Case Officer: Hannah Kersley
Reference: BN/39/22/T
Location: Copperfield, Old Rectory Drive, Eastergate, PO20 3XH
Proposal: 1no. sycamore tree (T1) - Crown lift of lower branches to 8m on north side only overhanging 1 Abercorn Walk to alleviate excessive shading & impact on neighbouring property. Ivy to be severed to alleviate impact also (no permission required)

Figure 2 Positions of final cuts

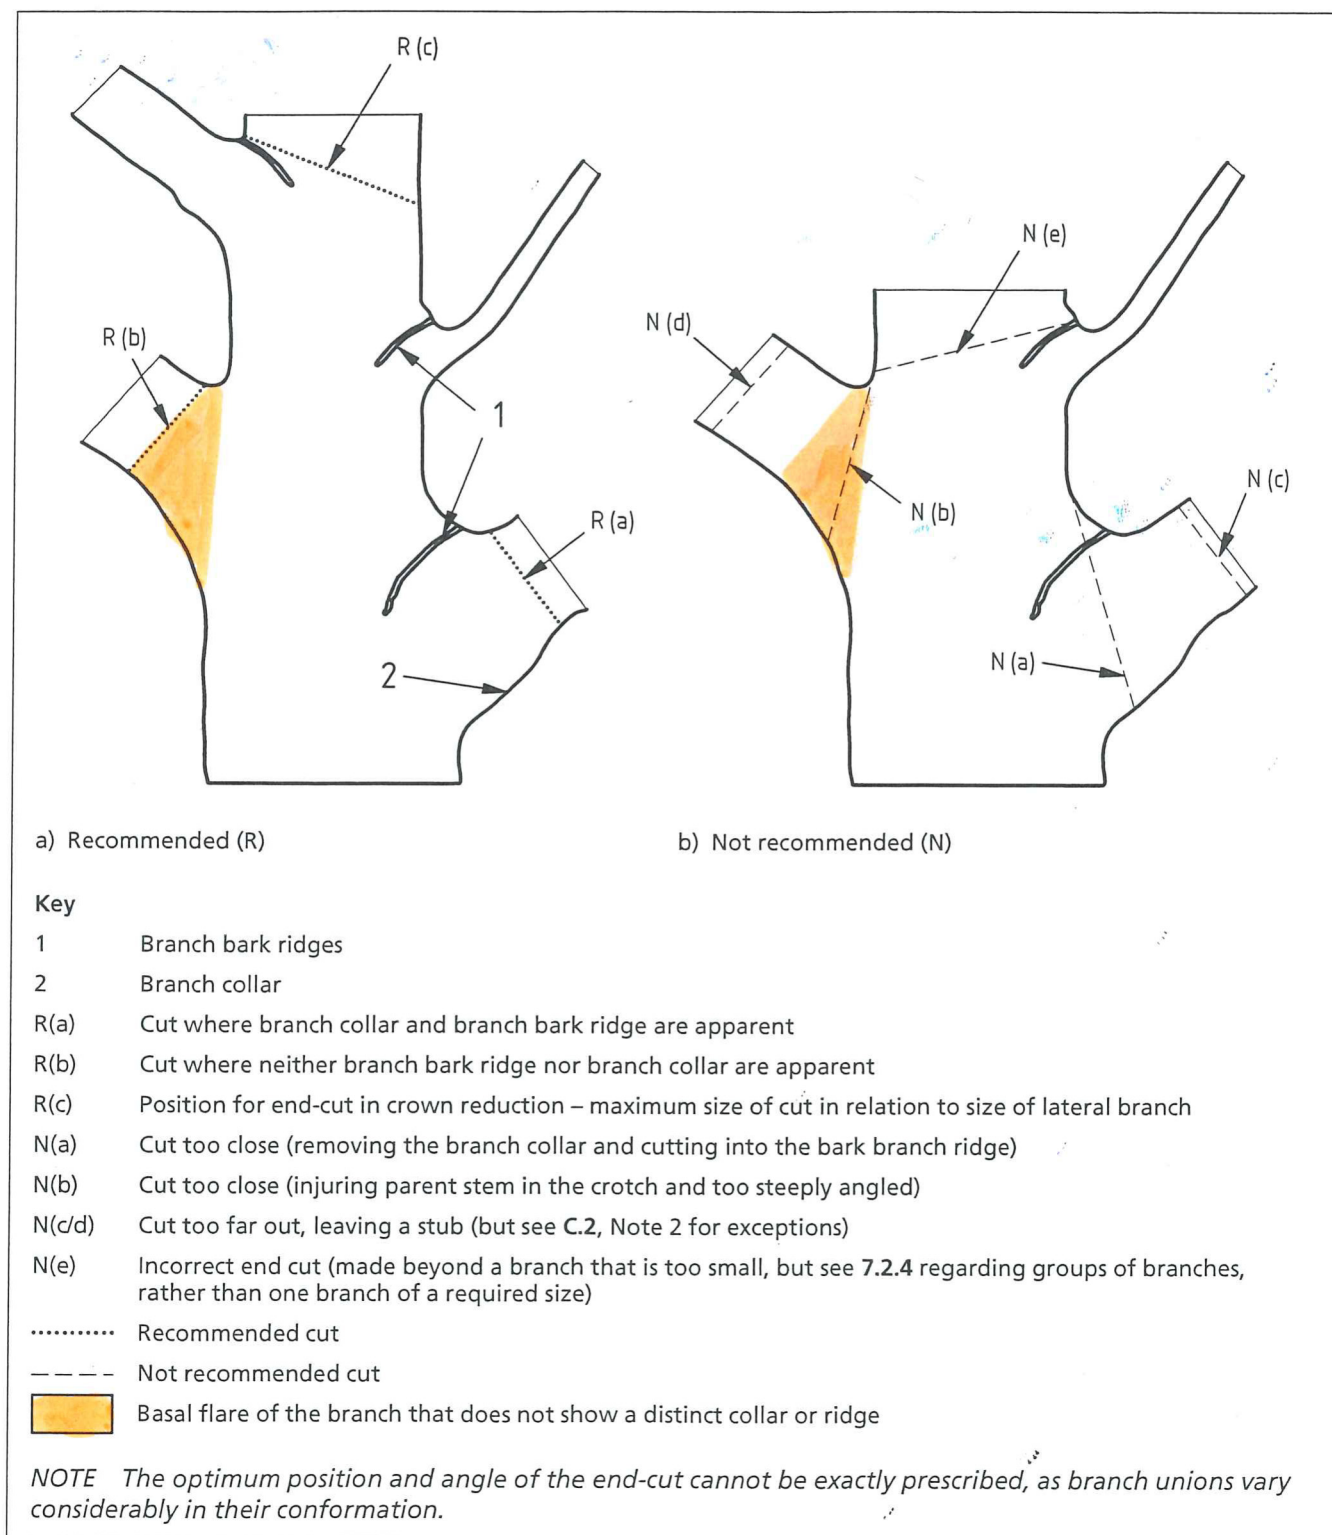
Part a) Where whole branches are to be removed and final cuts made close to the trunk or branch union they are to be made as shown in Figure 2 of BS3998:2010

Part b) Where branches are to be shortened back the final cuts are to be made at the correct angle shown in BS3998:2010 and adjacent to a live bud or lateral.
